## COUNCIL ASSESSMENT REPORT

### SYDNEY SOUTH PLANNING PANEL

<b>PANEL REFERENCE &amp; DA NUMBER</b>	PPSSSH-154 – DA 2023/0487
<b>PROPOSAL</b>	Demolition works, marina expansion, construction of a new carpark, alterations and additions to the existing club
<b>ADDRESS</b>	2 Wellington Street, Sans Souci (Gorges River LGA) – Lot 1 DP 956068, Lots 1, 2 & 3 DP 1012626, Lot 5A Sec 9 DP 1816, Lot 1 DP 957802, Lot 1 DP 441596, Lot 1 DP 106035, Lot 1 DP 78902
<b>APPLICANT</b>	The St. George Motor Boat Club Ltd
<b>OWNER</b>	The St. George Motor Boat Club Ltd
<b>DA LODGEMENT DATE</b>	25 October 2023
<b>APPLICATION TYPE</b>	Development Application - Designated (s4.10 of EP&A Act & Schedule 3 of Regulations) & Integrated Development (s4.46 of the EP&A Act)
<b>REGIONALLY SIGNIFICANT CRITERIA</b>	Section 2.19(1) and Clause 7(1)(b) of Schedule 6 of <i>State Environmental Planning Policy (Planning Systems) 2021</i> declares it regionally significant development as it proposes Particular Designated Development being marinas or related facilities that meet the requirements for designated development under Schedule 3, section 32 of the <i>Environmental Planning and Assessment Regulation 2021</i>

<b

**Figure 25: Height Blanket (Source: Innovate, Rev C July 2024)**

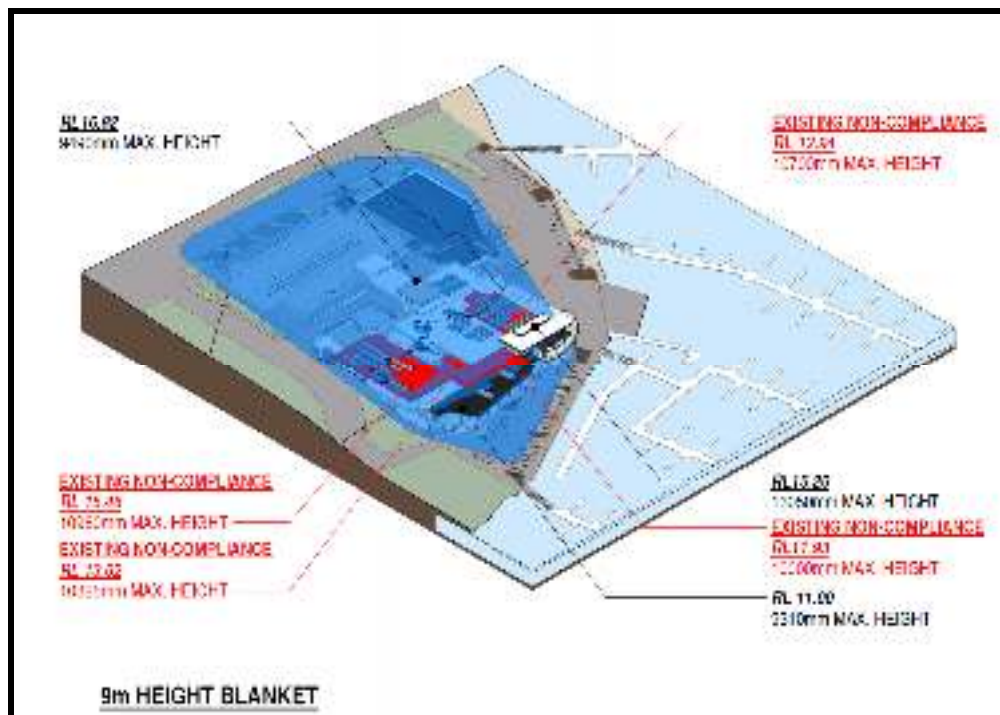
- The apex of the proposed roof structure over the new entry area/foyer on the first floor to 9.49 metres (exceedance of 0.49m); and
- The roof over the proposed ground floor outdoor terrace area adjoining the Marinas Edge Restaurant and bar area to the west side of the site to 9.310 metres (exceedance of 0.3m) adjacent to the Georges River foreshore.

The existing height non-compliances (in red) and the proposed height non-compliances (in black) are illustrated in the height blanket diagram in **Figures 25 and 26**.

A Clause 4.6 request has been provided seeking a variation to this development standard. However, the proposed alterations and additions to the existing club building have the benefit of existing use rights and therefore pursuant to section 4.67(3) of the EP&A Act, the provisions of planning instruments that derogate from Section 163 of the Regulation (permissibility of altering existing uses etc) do not apply to the assessment of this application. In this way, a Clause 4.6 request is technically not required for the application.

**Figure 31: Setback of Proposed Car Park to Wellington & Plimsoll Streets (Source: Innovate, Revision C, July 2024)**

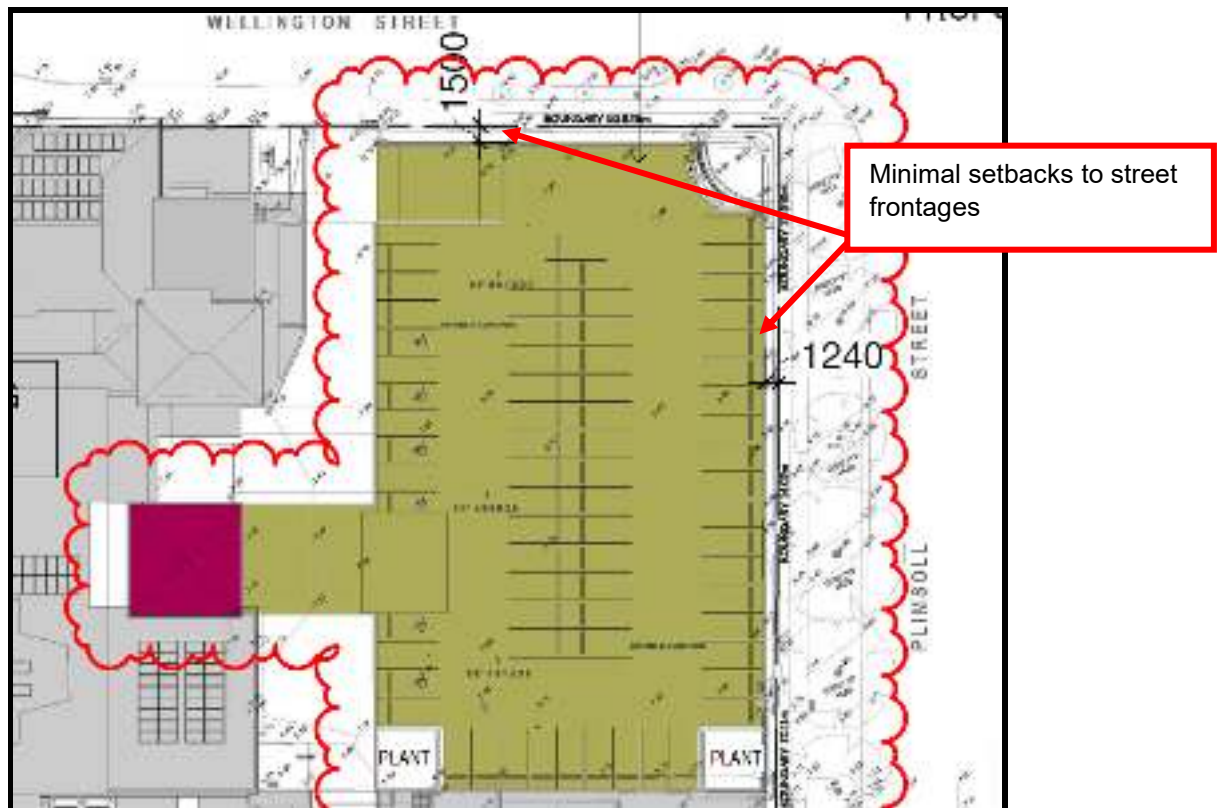
The proposed car park is located on a significantly reduced setback compared with the existing development in the low density residential area within which it is located (**Figure 31**) and is inconsistent with the prevailing setbacks. The proposal fails to integrate into the established streetscape character, resulting in a poor public / private interface treatment to Wellington and Plimsoll Streets.

**Figure 32: Plimsoll Street elevation (Source: Innovate, Revision C, July 2024)**

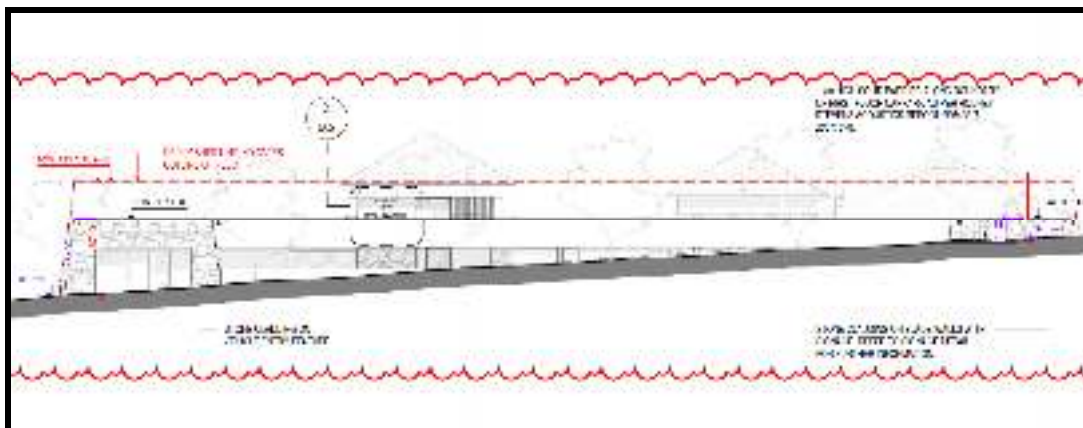
Exacerbating this minimal setback of the proposed car parking structure is the height and composition of the proposed walls of the car park (**Figures 32 and 33**). Whilst there has been a height reduction from the original proposal (Revision A plans) and from the initial amended plans (Revision B dated 29 April 2024), the car park walls still comprise the following heights (RL 11.80):

- 2.1 metres along Wellington Street
- 4.54 metres along Plimsoll Street at driveway entrance (southern end)
- 2.8 metres midway along wall on Plimsoll Street
- 1.42 metres at blade wall signage at corner of Wellington and Plimsoll Streets.

This car park comprises a solid wall structure, along Wellington Street where the entire length of the wall is of concrete construction. Plimsoll Street has a more varied composition, with the 1.4m high solid concrete barrier for the first floor of the car park comprising the majority of this frontage with some open form screening towards the driveway entry from Plimsoll Street. The proposed stone cladding on the vehicle entry point from Plimsoll Street at 4.54 metres high further exacerbates the bulk and scale of this structure from the street.

**Figure 33: Proposed Wellington Street frontage (Source: Innovate, Rev C, dated July 2024)**

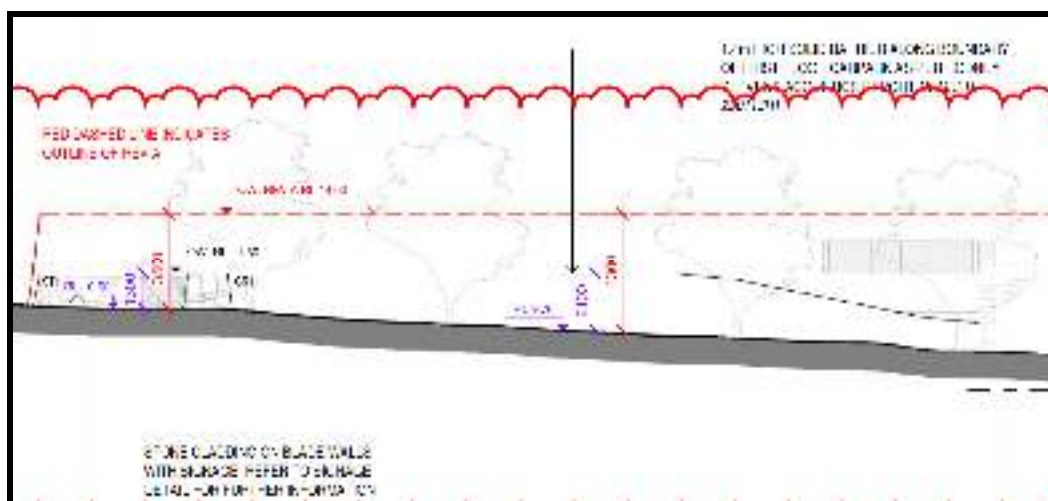
Arising from the combination of the height, lack of adequate setback and materiality of the structure, the proposed car park overwhelms the streetscape and results in a poor public / private interface. The lack of an adequate setback prevents adequate landscaping which could soften the appearance of the structure to the street from being provided.

The proposed car park does not provide an appropriate transition between the public/private domain as it does not provide any street activation or casual surveillance, which adversely impacts on pedestrian safety in this area. Pedestrian activity is encouraged in this area given the abundance of footpaths and public open space areas such as Anderson Park, Plimsoll Street reserve and the foreshore.

Figure 36: Photomontage showing new enclosed glazed area on ground floor (Source: *Innovate, Rev C, July 2024*)

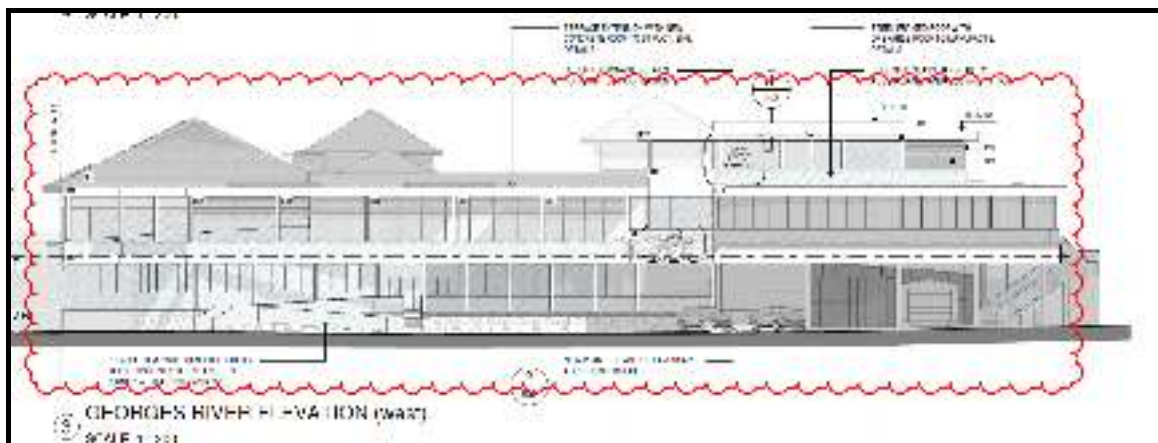
- (e) **Ground floor terrace areas** - The existing terrace area located off the St Kilda Room has open form sides with a glass balustrade along the edge of the existing concrete slab (the curved feature on the corner of the building), with a lightweight roof which is partially open to sky at the interface with the Lounge (**Figure 35**). However, the proposal involves enclosing this area with floor to ceiling glazing to the edge of the existing terrace and the addition of a rendered white horizontal banding (**Figure 36**).

This enclosing of this space accentuates the bulk and scale of this portion of the building as the open area becomes an enclosed space. The banding further emphasises the horizontal nature of the building and reduces the open area below which assist in minimises the bulk when viewed from the foreshore. This also results in more building bulk being brought forward and closer to the water, emphasising its size to the foreshore. These additions also result in the foreshore facing portion of the building comprising a length of 64 metres, which is a dominating building form in the locality.

**Figure 40: Proposed Landscaping along the Foreshore (Source: Site Design Studios, Rev C, July 2024)**

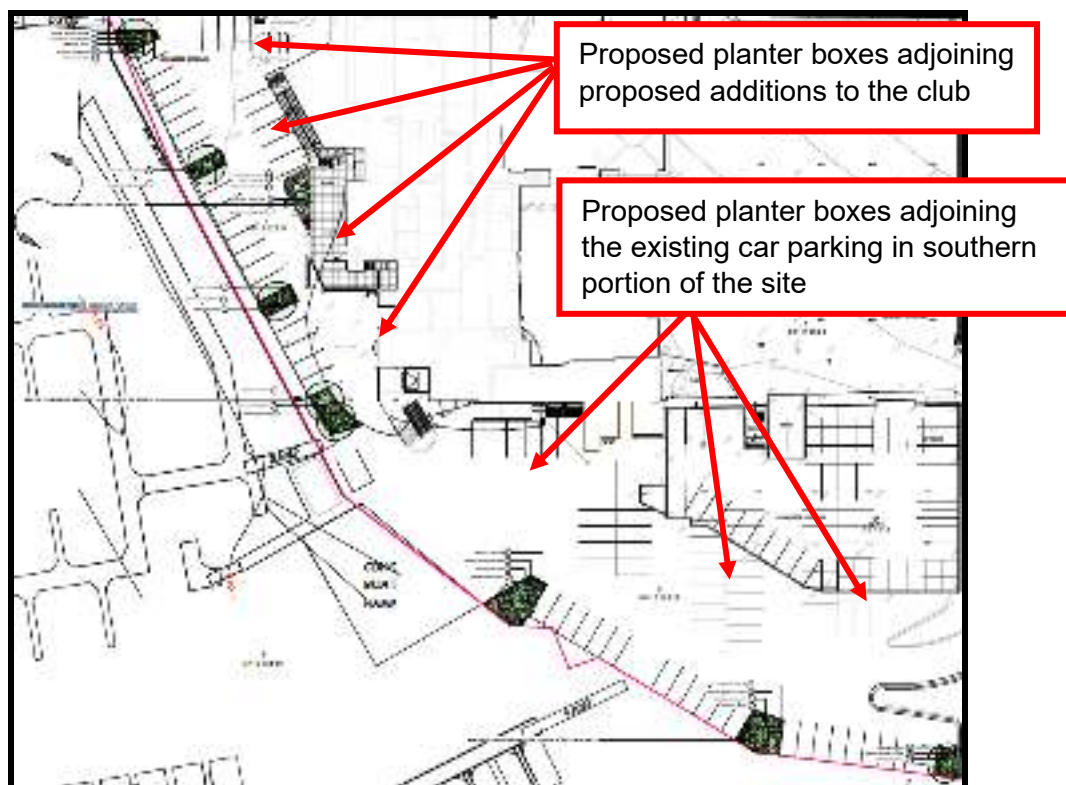
The proposal includes 4 planter boxes within the 70 metre foreshore frontage adjoining the proposed new terrace areas and 3 planter boxes along the car park to the south adjacent to the foreshore (**Figure 40**). While these planters are a minor improvement to the existing situation, they are limited in number and size and also provide a reasonably shallow planting depth such that groundcovers are the likely landscaping to be provided in such areas.

**Figure 41: Proposed planter detail (Source: Innovate, Rev C, July 2024)**

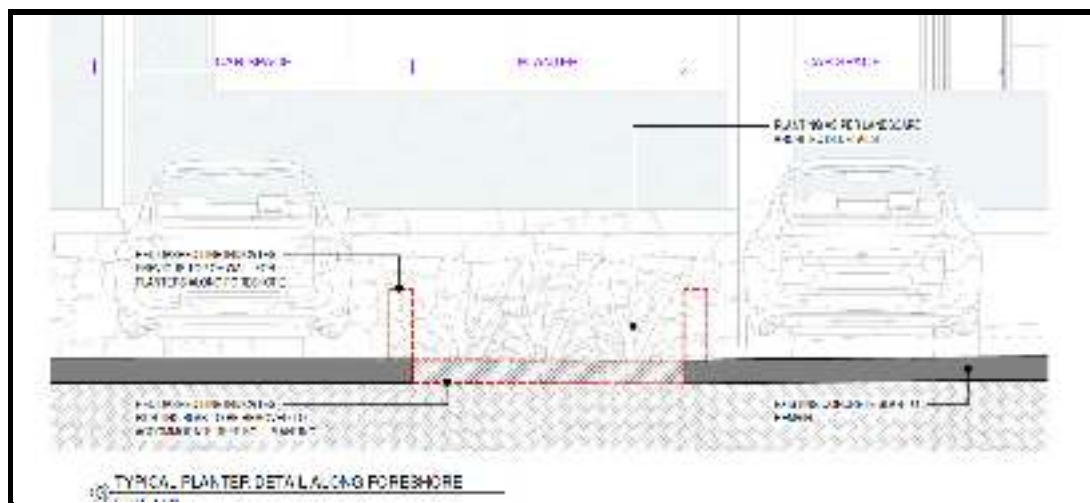
The borehole data contained in Table 1 of the *Geotechnical Investigation Report* prepared by Aargus dated 21 July 2023 revealed that sandstone was encountered at a depth of approximately 1 metre. This depth to sandstone and limited planting area, is likely to significantly restrict soil volumes in this area of the site, which will be inadequate for tree planting. This is confirmed in the planter detail in the architectural set (**Figure 41**) which illustrates groundcovers in the proposed planters.

Council's Landscape Officer also does not support the planting of *Cupaniopsis anacardioides* (Tuckeroo) on the foreshore as well as other proposed plantings given the use endemic genus and species has not been included.

Landscaping that involves small planters in discreet locations between car parking spaces and which can only accommodate groundcovers does not soften the proposed building form when viewed from the foreshore or enhance the views from the water. Such landscaping and small planters appear tokenistic and fail to minimise the visual impact of the proposed extensions to the club and car parking when viewed from the water. The scenic values of the foreshore are also not enhanced by the proposed landscaping. This lack of adequate landscaping in the foreground does not offset the proposed three (3) storey built form which will dominate the views from the water. The result is that there continues to be a significant imbalance in the ratio of plants and soft landscaping to hard surfaces at the foreshore interface, exacerbating the bulk and scale of the proposed additions to the club.

**Figure 53: Manoeuvring paths for SRVS to access proposed ground floor loading dock**  
(Source: McLaren, 23 July 2024)

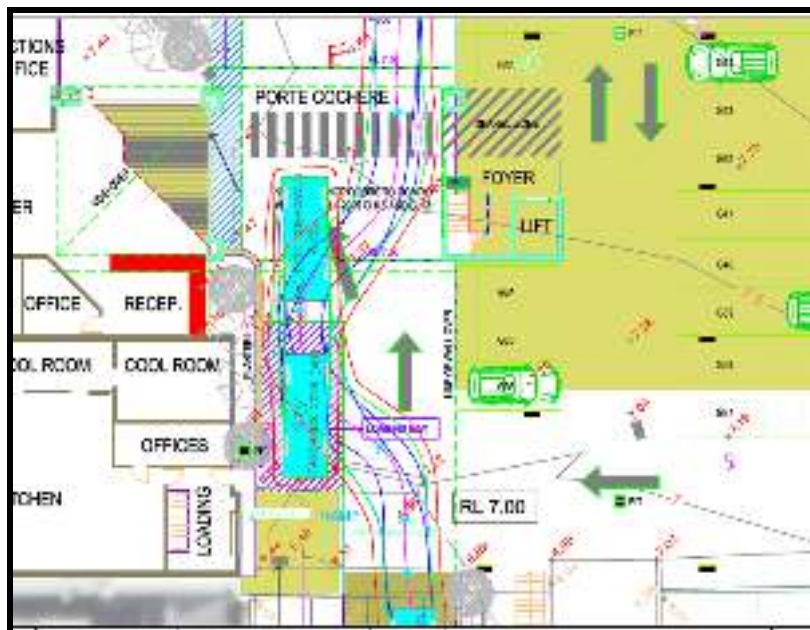
A further concern with this extended ground floor loading dock is that this area is located adjoining the main pedestrian entry to the club, with trucks accessing the loading bay required to carry out forward and reversing movements in close proximity to the main pedestrian crossing linking the upper-level car parking area to the main entry to the club (**Figure 53**). It is considered unsafe for larger vehicles to be manoeuvring in an area of pedestrian activity and the proposed loading facility is therefore not supported.

This manoeuvring area also adjoins the main vehicle throughfare for vehicles entering the site from Plimsoll Street to access the proposed first floor level of the new car parking area (**Figure 54**). It is also the only path for vehicles exiting from the existing two (2) storey car parking structure to exit the site via Wellington Street. these vehicle movements make this area of the site a busy vehicle throughfare in the vicinity of the main entry to the club, without the additional burden of service vehicles manoeuvring into and out of an extended loading dock.

**Figure 54: Manoeuvring path for vehicles entering the site** (Source: McLaren, 23 July 2024)

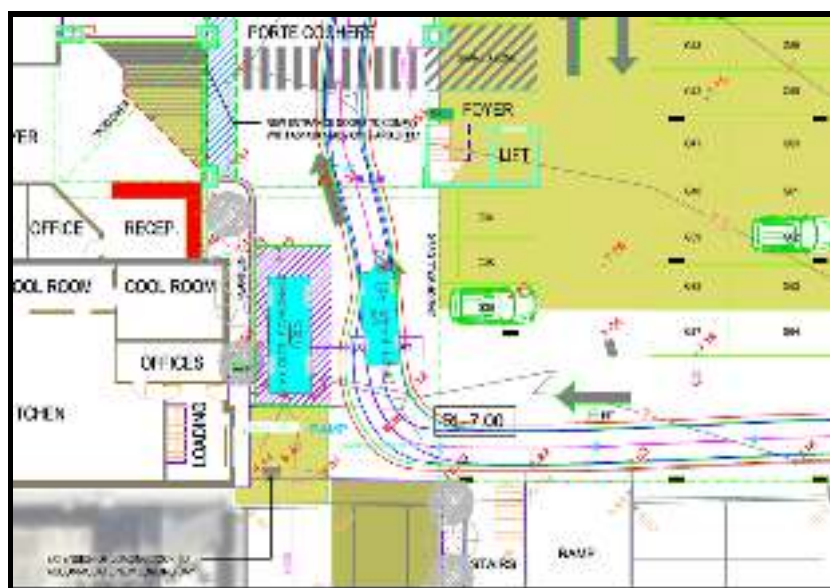
Additionally, the service vehicles will be required to exit the site under the proposed Porte Cochere, which increases its height and consequently the height of the first floor of the new car park (discussed in the first issue in this section).

**Figure 55: Proposed SRV Ramp (Source: Innovate, Rev C, July 2024, Dwg 503)**

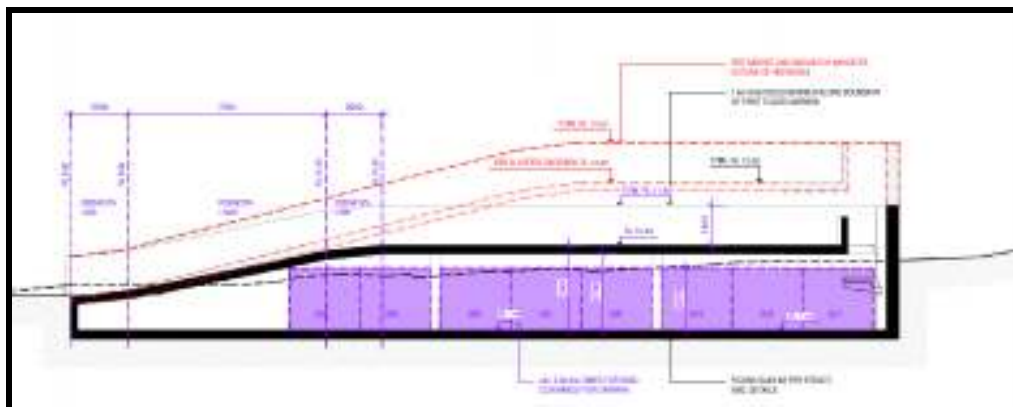
Council's Traffic Engineer raises concerns with this proposed new SRV ramp as the design proposes gradients and gradient changes that do not satisfy the requirements of AS 2890.2:2018 *Parking Facilities Part 2- off street commercial vehicle parking* for use by an SRV.

A proposed gradient of 20% on the main part of the ramp exceeds the maximum gradient of 15.4% (Section 3.3.3.2 – Table 3.2 in the Standard) and the transition sections at the foot and top of the ramp do not satisfy length and gradient requirements. The ramp would need to be extended in length to provide satisfactory use by the SRV which may impact on the operation and vehicle movements in the car park at the foot of the ramp (**Figure 55**).

Accordingly, the proposed loading dock extension and SRV ramp are considered to be unsatisfactory and are not supported.
